## DSP-20028

# Brandywine Commercial Center

STAFF REPORT

SUBJECT: Detailed Site Plan DSP-20028  
Type 2 Tree Conservation Plan TCP2-034-2020  
Brandywine Commercial Center

Figure 1: Site Plan

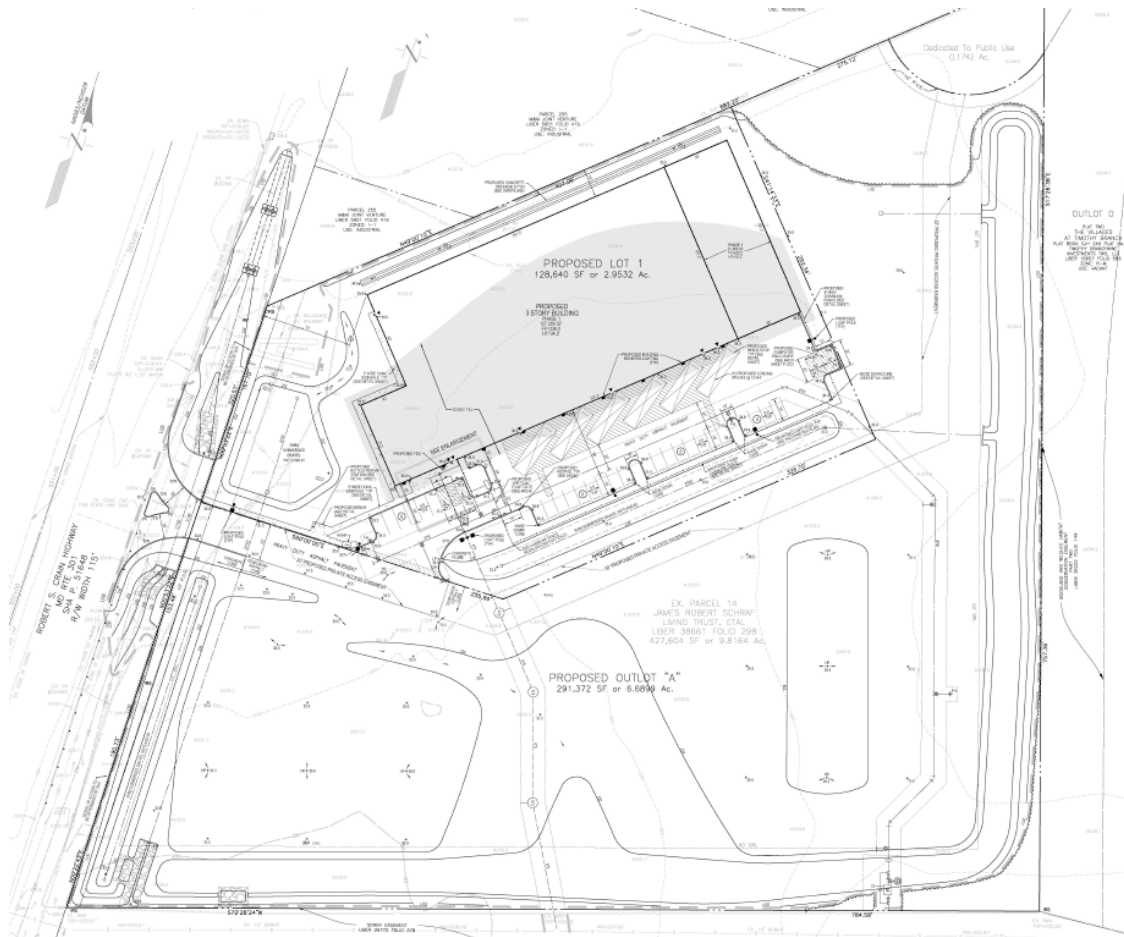
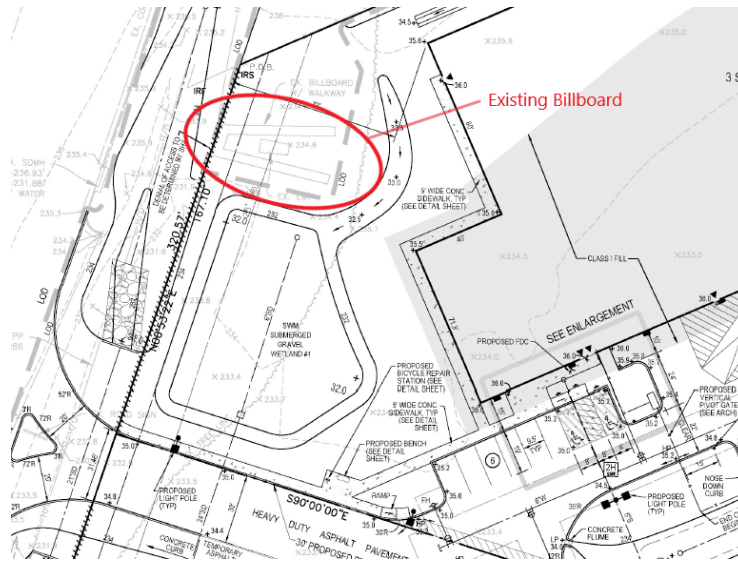
Sidewalks and crosswalks are clearly marked and provide separated routes for pedestrians and vehicles. A diagonal curb ramp connecting the crosswalk and vehicle entrance is shown on the DSP and is not acceptable, as users are directed into the center of an intersection. Staff recommends that the plans be revised to provide either a parallel or perpendicular Americans with Disabilities Act-accessible curb ramp that will direct users directly to the crosswalk and supports barrier free pathways to accommodate persons with disabilities.

- d. Revise the diagonal curb ramp connecting the crosswalk and vehicle entrance to provide either a parallel or perpendicular Americans with Disabilities Act-accessible curb ramp that will direct users directly to the crosswalk.
